To: Kristopher Byrd, Well Construction and Compliance Section Manager
From: Travis Kelly, Well Construction Program Coordinator
Subject: Review of Water Right Application G-18906
Date: May 26, 2020

Application # G- 18906

TO: Water Rights Section Date May 19, 2020
 FROM: Groundwater Section J. Hackett
Reviewer's Name
 SUBJECT: Application G- 18906 Supersedes review of _____
Date of Review(s)

Water-Level Trends in Nearby Wells

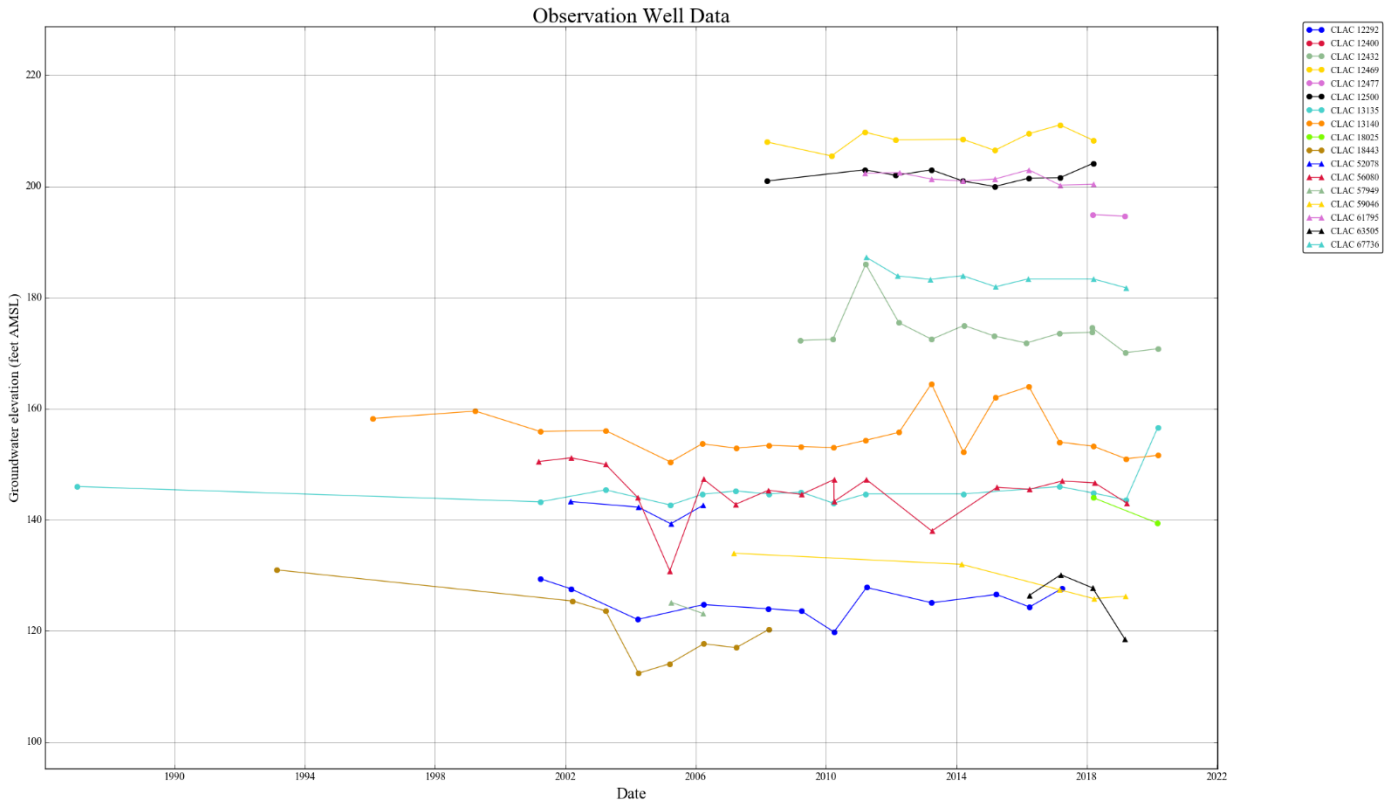
Because the productive water-bearing zones are thin and confined, pumping impacts will spread out over a broad area resulting in large seasonal fluctuations and widespread well interference. Water levels in nearby wells (see attached hydrograph) show declines of about 2 feet per year over the last 10-15 years at about 1 mile to the west. These appear to be part of a broad decline centered in the Marks Prairie area. However, water levels at about 1 mile to the north are stable or show declines of less than 1 foot per year over the last 10 years. Maps published by the U.S. Geological Survey (Prof Paper 1424 A, B) indicate that the thickness of productive sands increases immediately to the south of the applicant’s wells. This suggests a larger water supply in the vicinity of the wells than in areas to the north and west.

Uncertainty about the continued stability of the ground water resource in the immediate vicinity of the well indicates the need for a water-level monitoring condition.
